The Peelle Company

TECHNICAL BULLETIN

SPECIAL INSTALLATION INSTRUCTION

SUBJECT: REPLACEMENT DOOR MOTOR

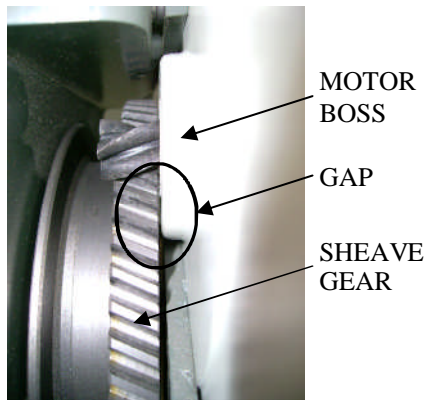
DESCRIPTION: PEELLE HAS DISCOVERED THAT WHEN REPLACING A 056910M DOOR MOTOR, THE BOSS ON THE MOTOR FACE COULD INTERFERE WITH THE EXISTING GEAR ON THE SHEAVE ASSEMBLY.

ACTION: BEFORE INSTALLING A NEW 056910M DOOR MOTOR, PLACE THE MOTOR IN POSITION AND CHECK THE GAP BETWEEN THE MOTOR BOSS AND THE SHEAVE GEAR. IF THE BOSS IS LESS THAN 1/16" AWAY FROM THE GEAR, USE THE MOTOR SPACER SHIM INCLUDED WITH THE REPLACEMENT MOTOR.

MOTOR SPACER SHIM. MAY NOT BE EXACTLY AS SHOWN.

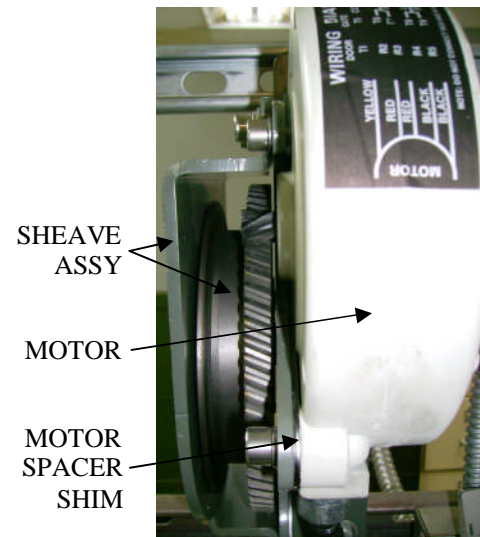
1. HOLD NEW MOTOR IN PLACE AND CHECK GAP
IF LESS THAN 1/16" GAP, USE MOTOR SPACER SHIM. IF GAP IS 1/16" OR GREATER, INSTALL MOTOR WITHOUT MOTOR SPACER SHIM.

2. PLACE MOTOR SPACER SHIM ON SHEAVE ASSEMBLY
USE 3/8" x 3/4" SOCKET HEAD CAP SCREW AND 3/8" WHIZ NUT TO HOLD MOTOR SPACER SHIM IN PLACE. USE BOTTOM MOUNTING HOLE.

3. REPLACEMENT MOTOR MOUNTED ON SHEAVE ASSEMBLY WITH MOTOR SPACER SHIM
